Federal Register

[Docket No. 98–NM–300–AD; Amendment 39–14355; AD 2005–22–11]

Airworthiness Directives; Mitsubishi Model YS–11 Airplanes, and Model YS–11A–200, YS–11A–300, YS–11A–500, and YS–11A–600 Series Airplanes

ACTION: Final rule.

HUB CRACK - VIEW FROM TOP

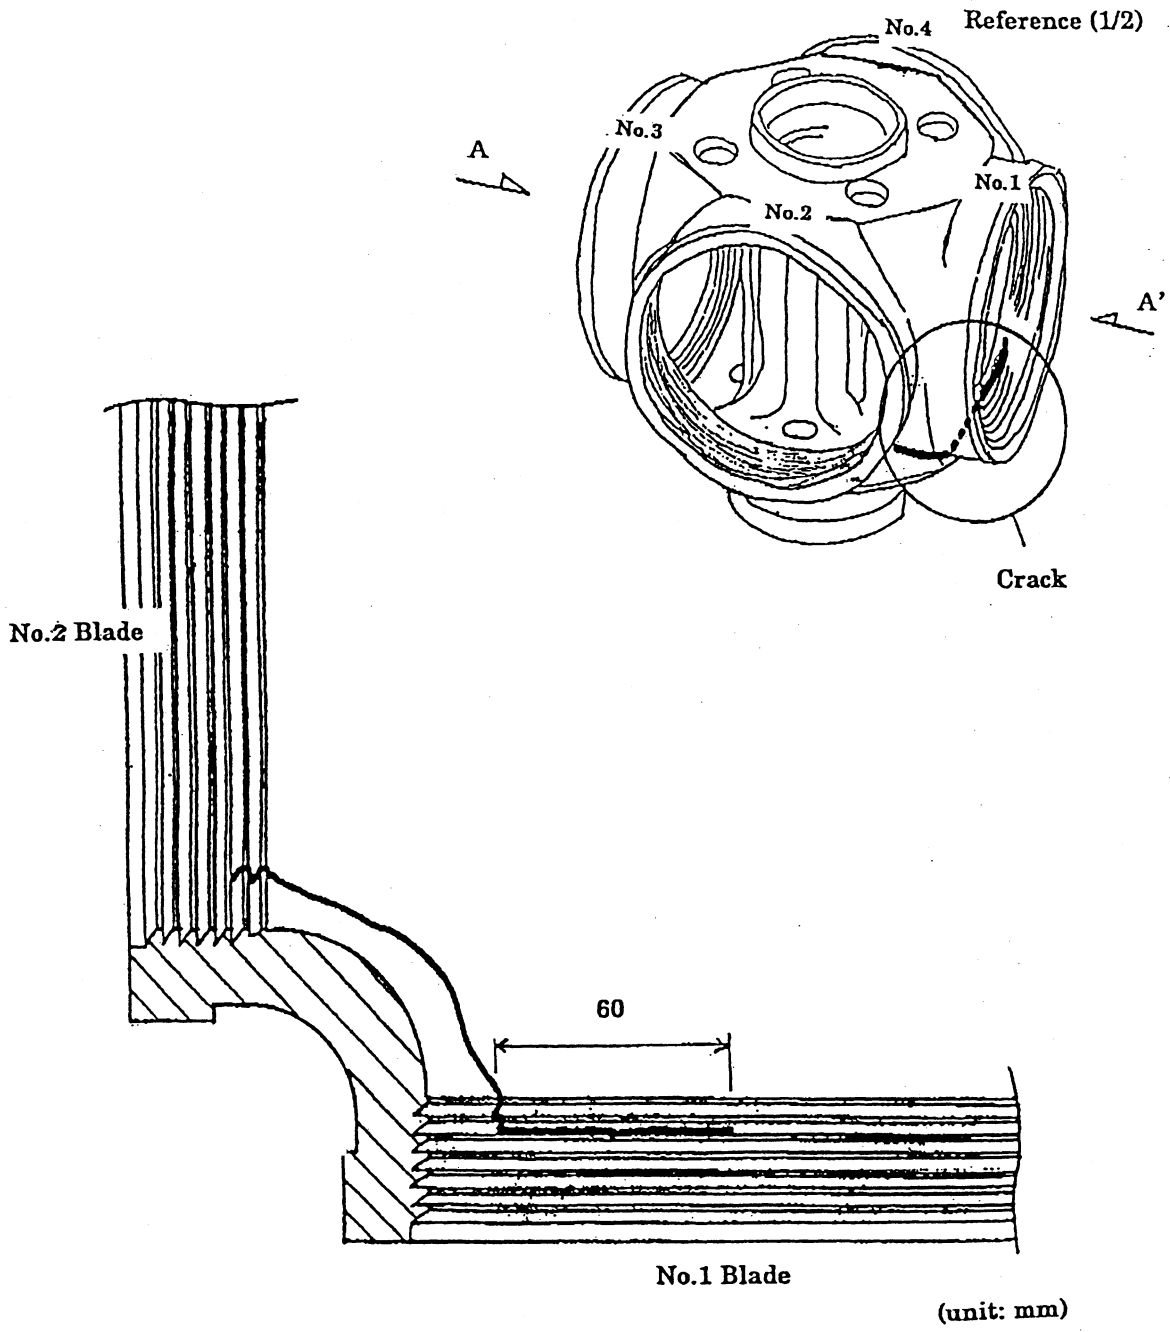
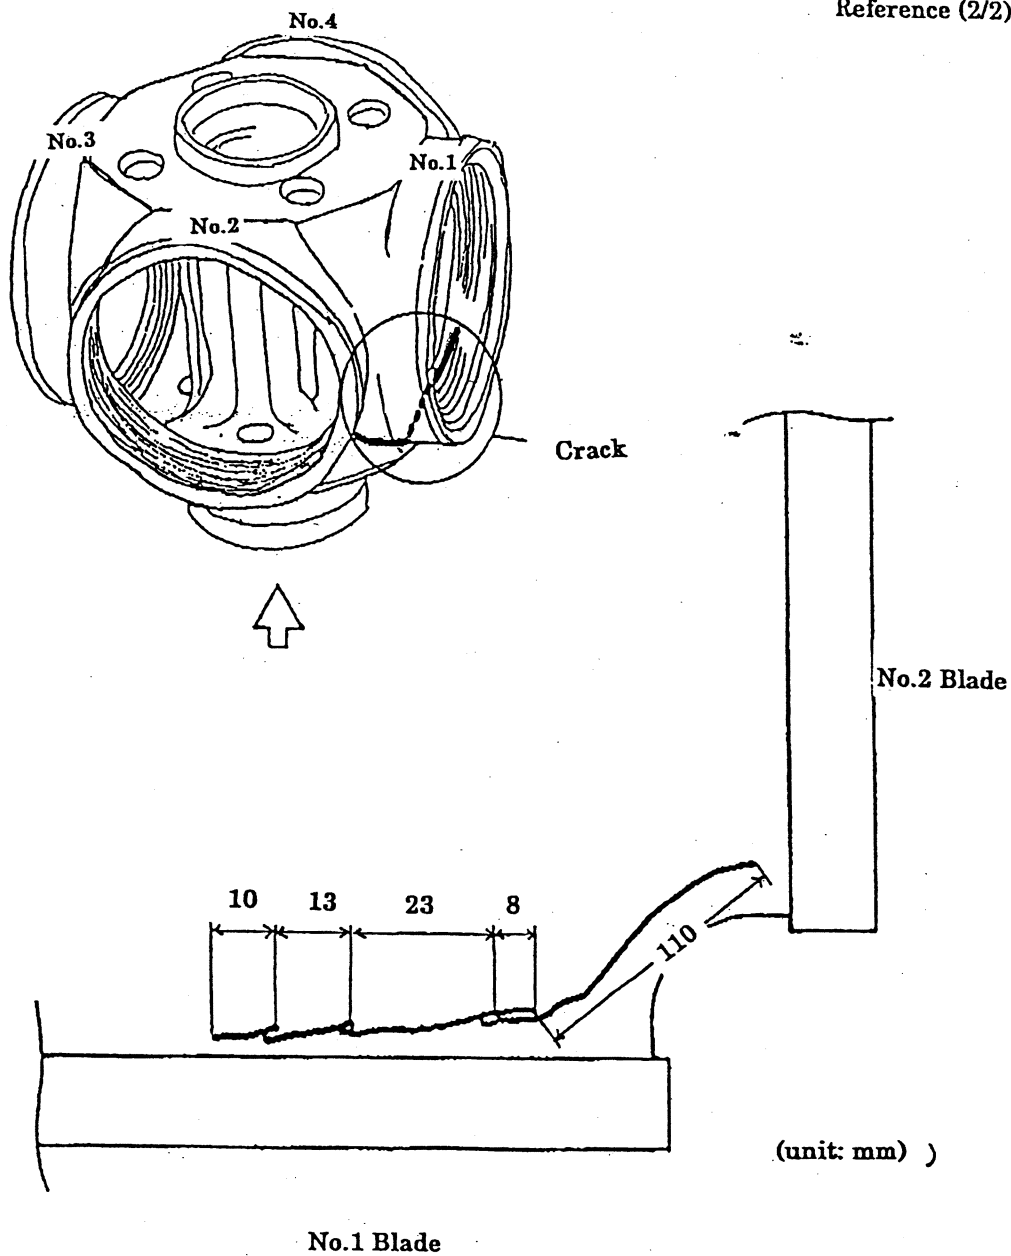
(a) Within 25 flight hours or 30 days after the effective date of this AD, whichever occurs first, remove the spinner and perform a detailed inspection for cracking of the propeller hub in the crack area shown in Figure 1 of this AD.

(1) If no crack is found, repeat the actions required by paragraph (a) of this AD thereafter at intervals not to exceed 25 flight hours.

(2) If any crack is detected, prior to further flight, replace the hub with a new hub according to a method approved by either the Manager, Los Angeles Aircraft Certification Office (ACO), FAA; or the Japan Civil Aviation Bureau (JCAB) (or its delegated agent). Chapter 61 of the Nihon Aeroplane

Manufacturing Company YS-11 and YS-11A Aircraft Maintenance Manuals is one approved method. Repeat the actions required by paragraph (a) of this AD thereafter at intervals not to exceed 25 flight hours.
